**SUSQUEHANNA STEAM ELECTRIC STATION  
PROPOSED AMENDMENT NO. 283 TO  
UNIT 1 LICENSE NPF-14: MCPR SAFETY LIMITS AND  
REFERENCE CHANGES SUPPLEMENTAL INFORMATION  
PLA-6017**

**Docket No. 50-387**

**Attachment to PLA-6017**

**Supplemental Information**

# SUSQUEHANNA UNIT 1 CYCLE 15 REFERENCE CORE LOADING PATTERN

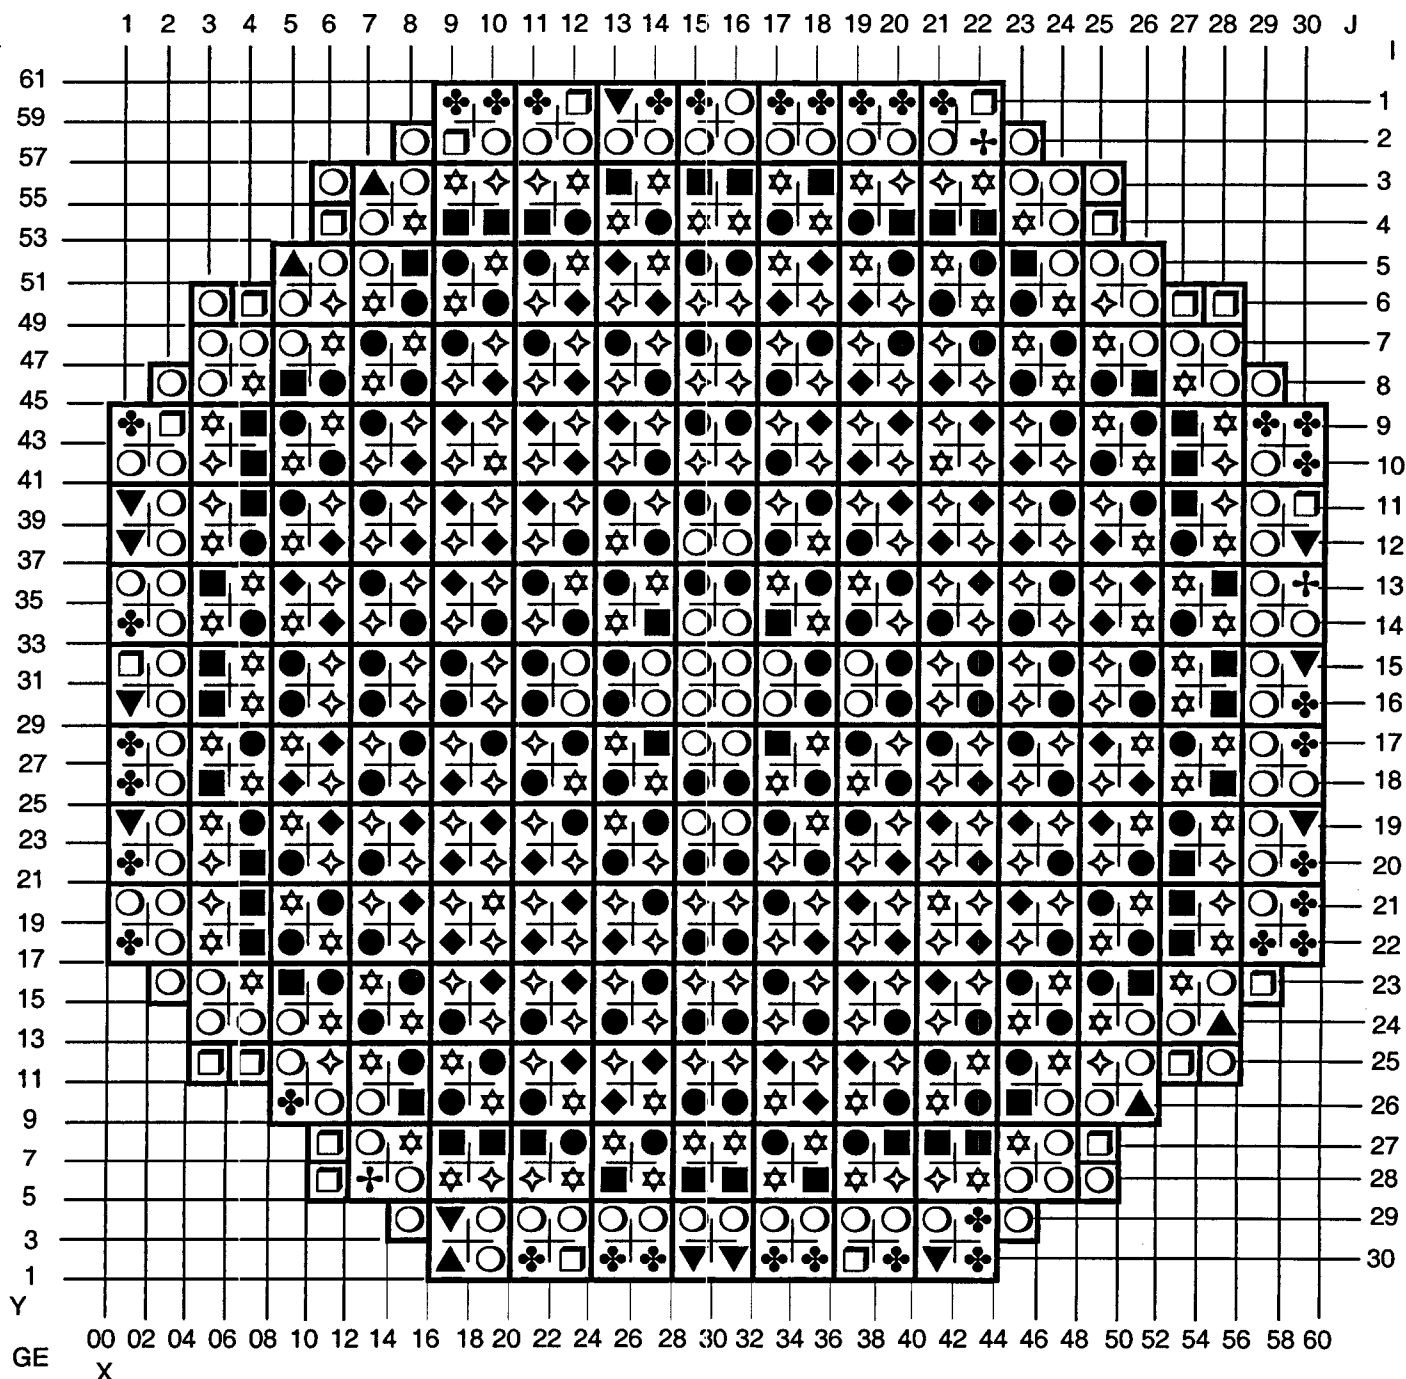
Reference 1 provided in Attachment 4 a "Preliminary Unit 1 Cycle 15 Core Composition" and in Attachment 5 a "Preliminary Unit 1 Cycle 15 Core Loading Pattern." The final core loading pattern is provided in the Attachment to this letter. The Unit 1 Cycle 15 preliminary core loading provided in PLA-5990 was revised to mitigate the potential for excessive friction in peripheral control cells. No changes were made to the loading of interior control cells. The design maximizes the use of SQA-12 assemblies that were re-channeled during the November 2005 Unit 1 maintenance outage to improve clearances within the cell. The figure shows the locations of assemblies that received a new fuel channel during the November 2005 Unit 1 maintenance outage.

The changes to the Unit 1 Cycle 15 core loading do not change the proposed 2-loop and single loop MCPR Safety Limits previously submitted in PLA-5990. In addition, the core composition provided in PLA-5990, Attachment 4, remains unchanged.
